核四廠一號機安全釋壓閥洩放管路(SRVDL)
系統查證研究報告

中華民國九十三年八月

A Study of Safety Related System Inspection on SRVDL System of
Taipower's Fourth Nuclear Power Plant Unit 1

附件六 Minimum wall thickness

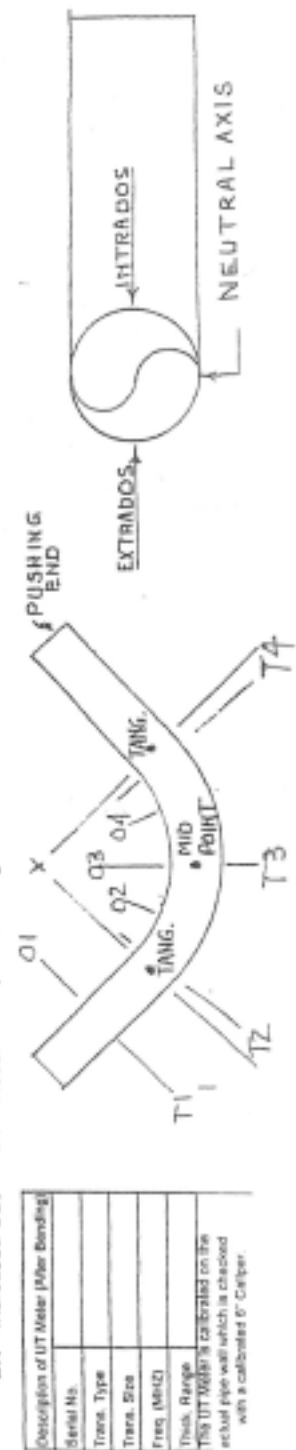
- (a) 1B21-PSP-004 超音波檢測報告中彎管有些管壁厚度低於規定最小值 (附件六)，BF Shaw 公司自行開立 NCR-1453 (附件七)，並通知 GE 公司要求解釋，GE 回覆文件 DDR-62.2213.1-8 (附件八) 中認為 BF

公司所量測之彎管厚度值仍然符合 B&V 公司 31113-0A10-2102 Rev.1 中之厚度需求 (0.475")。故該管件仍符合規定要求。

圖三：穿越器

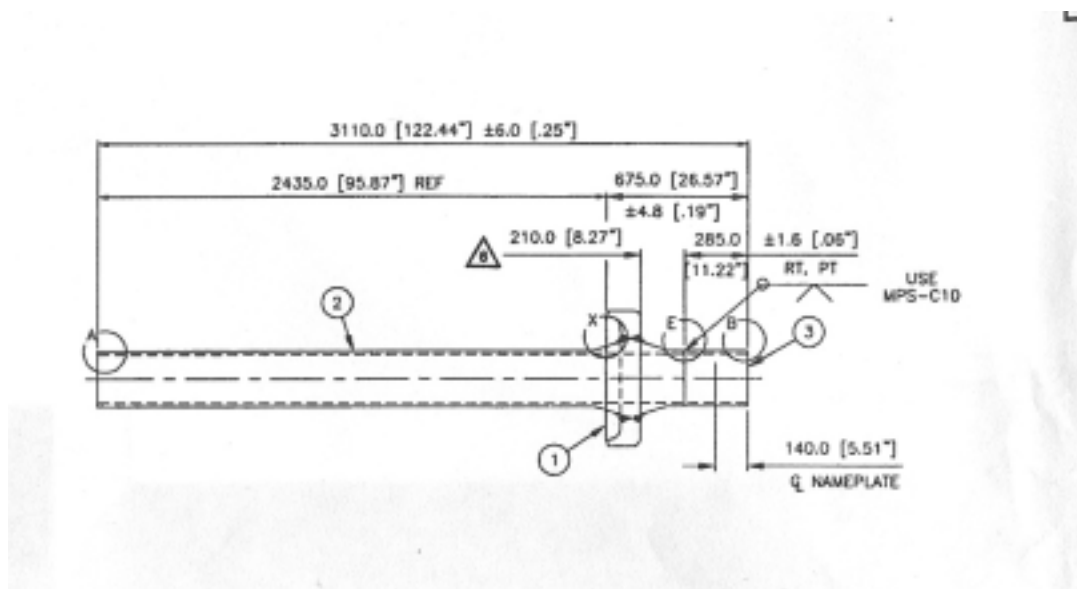
穿越器(如圖三)為 TAYLOR FORGE ENGINEERED SYSTEMS. INC. 製造，管材 SA182 Grade 316L 符合規範要求，並執行 PT 檢測，安裝在隔膜地板混凝土，為了與上游的碳鋼管銲接，穿越器於工廠製造時已事先銲接一截 SA-333 Gr6 碳鋼管，查證 1B21-MPEN-0008A 文件，材質符合規範要求，SA-333 Gr6 依規定執行水壓測試。依照 Purchase Specification for Containment Mechanical Penetration Assemblies 的 7.2.1 節規定穿越器要執行水壓測試(Hydraulic Tests)，但在 QRP 缺此項測試文件。

照片一、現場部分 SRVDL 不銹鋼管路上存有銲渣痕跡

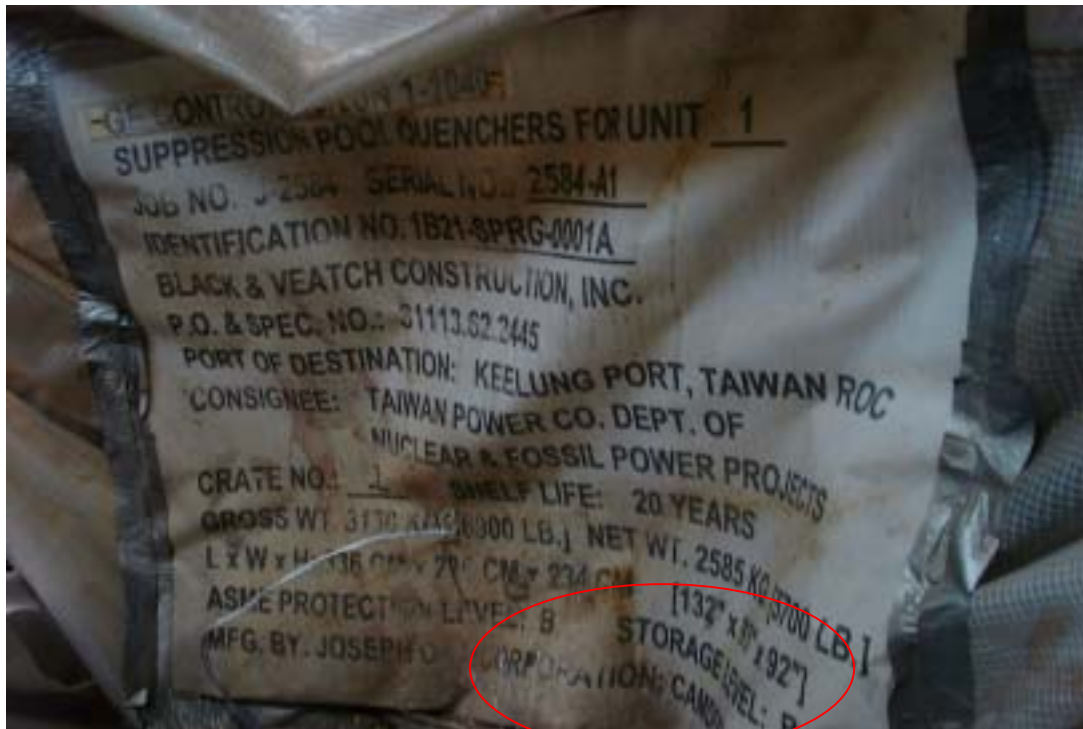
現場查證 SRVDL 系統重要組件倉儲現況，其中 Vacuum Breaker、Diaphragm floor 以上之碳鋼管、Mechanic Penetration 均置放於庫房或管路存放處，倉儲狀況符合規定。Diaphragm floor 以下之管件及 Quencher 等不銹鋼組件則已由汽源課領出，置放於濕井預計安裝處。視察發現，部分管路上存有銲渣痕跡(照片一)，且部分 Quencher 之保護膠套有灼傷焦黑之狀況(照片二)，已將此現象向主辦課反應，請其儘速妥善處理，以期提供設備品質更多保障。施工處已利用塑膠帆布覆蓋(照片三)，Quencher 設備保養維護已有改善。另依據 Quencher 上之組件說明(照片四)，原廠家要求之儲存等級為 B(室內儲存，室溫維持在 5°C 至 48°C 之間)，Quencher 放置現場為戶外且地面處於長期積水狀況，設備雖然已利用枕木架高，然而長期而言 Quencher 置放於濕井現場，其儲存條件應無法滿足原廠家之儲存等級要求。

照片二、現場部分 Quencher 之保護膠套有灼傷焦黑之狀況

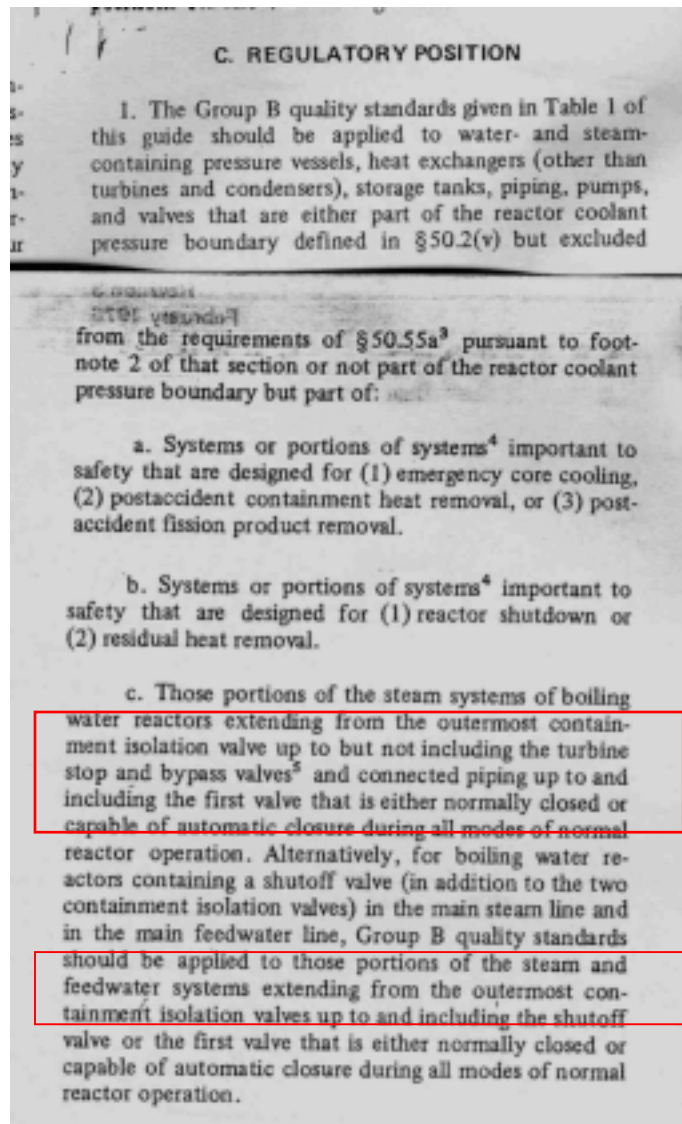
5.1 依據 ABWR 訓練教材第三篇第一章主蒸氣系統(B21-Main Steam System MS)敘述，肆、重要設備中第三、安全釋壓閥之 9. 釋放閥之排洩管之(2)各閥排洩管設有膨脹伸縮箱(Expansion Bellow)，供作閥動作時熱漲冷縮緩衝之用。但是查閱施工處之 P&ID 及 ISO 相關圖面資料，均未發現有膨脹伸縮箱或類似設備存在，特向核四廠原作者請教，但原作者表示因時間已久不復記憶，經其協助查閱 GE 之英文訓練教材及其原始文件 Main Steam System (MS) System Design Description 亦未發現類似敘述。再查閱核二廠相同系統設計狀況，根據核四廠提供之核二廠圖面，未發現類似設計。上述發現復請施工處汽源課確認後，證實訓練教材相關敘述應為錯誤，已建議台電公司予

以修訂。另外，訓練教材第二篇第四章 自動釋壓系統(Automatic Depressurization System ADS)圖八：SRV 與 MSIV 之相關參數設定中將 Non-ADS 之 SRV 歸類為 Non-Safety-Related，與 PSAR 之規定不符，亦建議台電公司一併修正。
